Specification for radio disturbance and immunity measuring apparatus and methods –
Part 1-4: Radio disturbance and immunity measuring apparatus –
Ancillary equipment – Radiated disturbances

CORRIGENDUM 1

Figure C.8 – Validation factor for a large loop-antenna of 2 m diameter

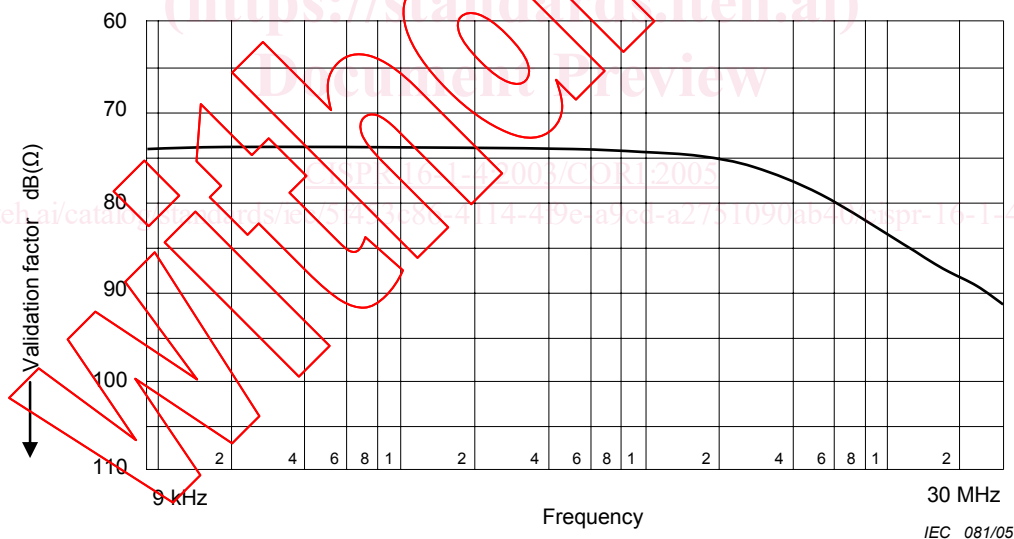
Replace the existing Figure C.8 by the following new Figure C.8:

Replace the third paragraph of Clause C.4 as follows:

In each of the eight positions, the validation factor [expressed in $\text{dB}(\Omega) = 20 \log(V_{go}/I_1)$] of the open circuit voltage of the RF generator (V_{go}) and the measured current (I_1) shall not deviate more than ± 2 dB from the validation factor given in Figure C.8.
